Subject: Response to NRC Request for Additional Information Regarding the Application of the Alternative Source Term Guidelines to the Re-analysis of the Fuel Handling Accident Dose Consequences

**ENCLOSURE 1 TO
NRC-01-0036**

**FERMI 2 NRC DOCKET NO. 50-341
OPERATING LISENCE NO. NPF-43**

**RESPONSE TO NRC REQUEST FOR ADDITIONAL INFORMATION
REGARDING THE RE-ANALYSIS OF THE FUEL HANDLING ACCIDENT**

A-2068

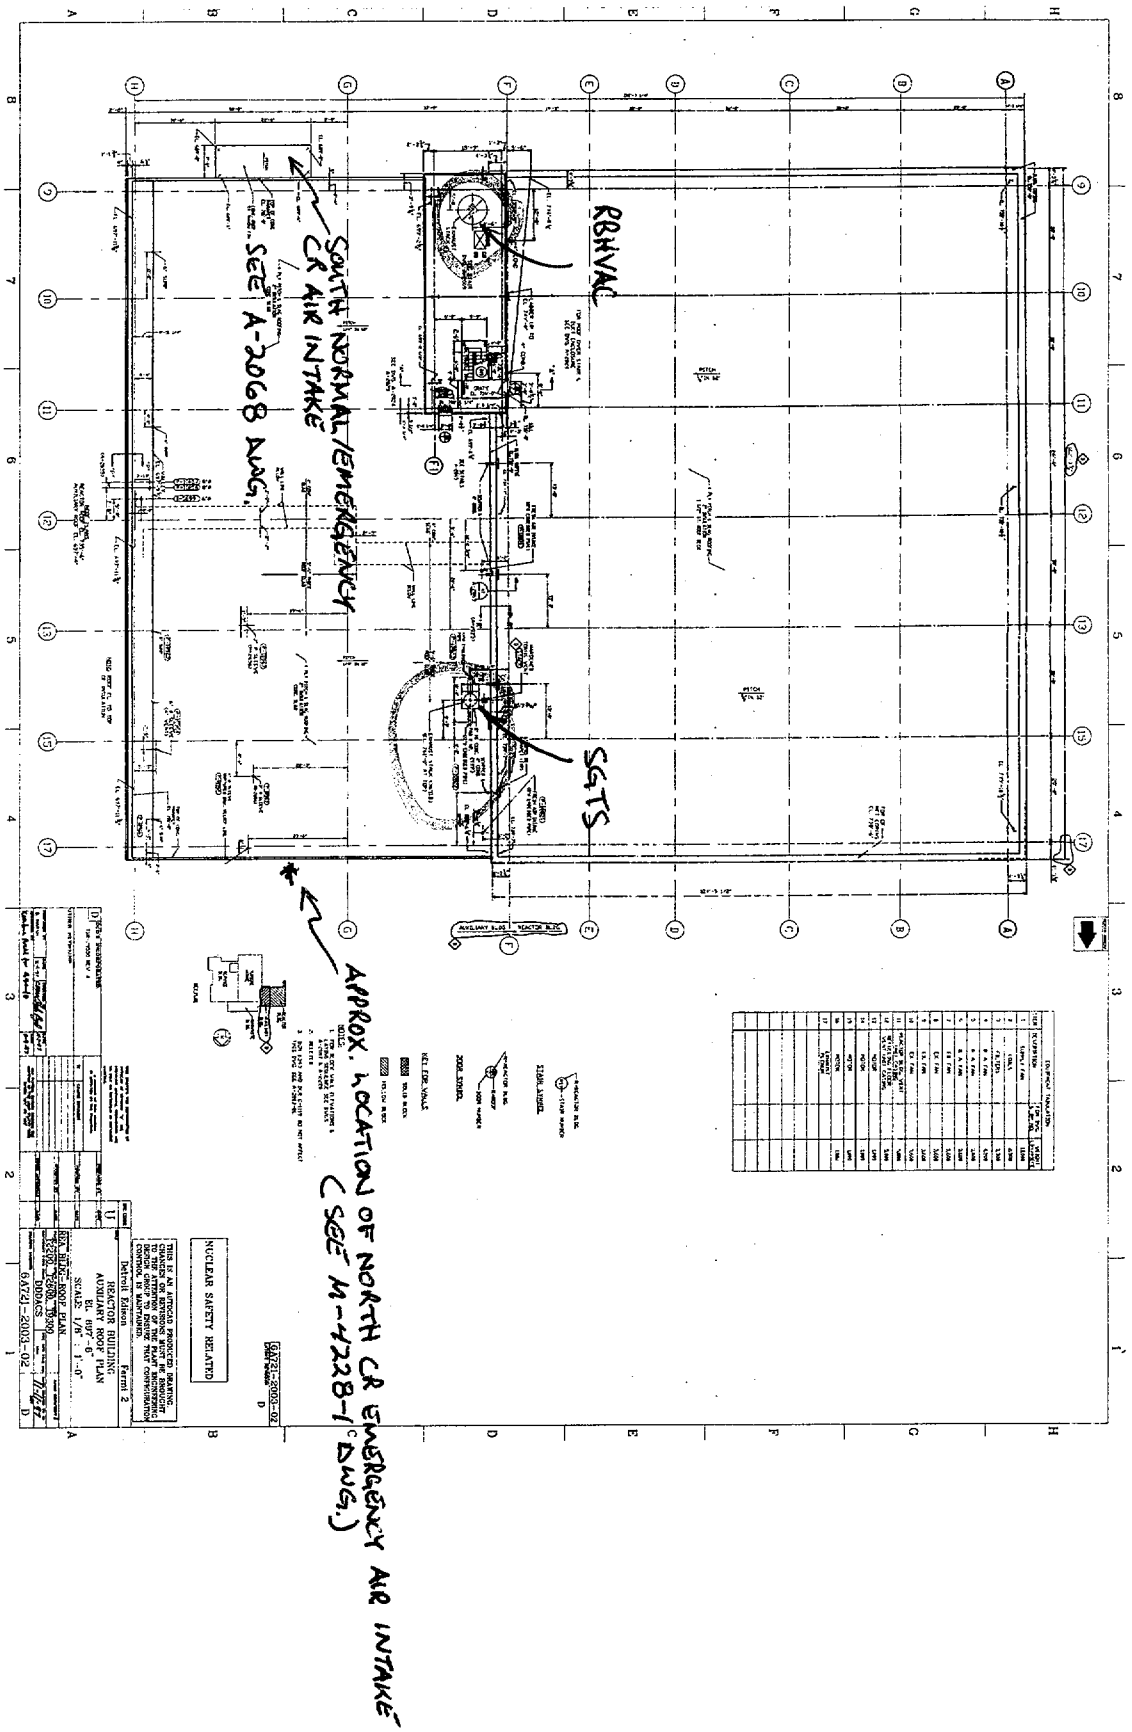
Describe the specific inputs, assumptions and bases used with the ARCON96 methodology so as to result in the limiting dose for each accident scenario. A copy of the ARCON96 printouts is acceptable to show inputs. Was the physical height of the vent or other release location assumed? Are distances the shortest distance from the postulated release location to the intake location? Are all directional inputs defined in terms of true north? References to figures showing structures, dimensions, and distances may also be helpful in describing the postulated transport of the effluent. If the figures are drawn to plant or magnetic north, what is the relationship to true north? If more than one release to the environment/transport scenario could occur (e.g., loss of offsite power and non-loss of site power, single failure), were comparative χ/Q calculations made to ensure consideration of the limiting dose?

Drawing Number	Revision	Title
A-2068	E	Louver Air Intake Houses, Reactor Building
A-OB-2000	0	Outage Building Floor Plans
M-2257	H	Vent and Duct Layout, 5 th Floor Reactor Building 684'-6"
M-4228-1	A	Isometric, Emergency Outside Air Intake to Makeup Filter
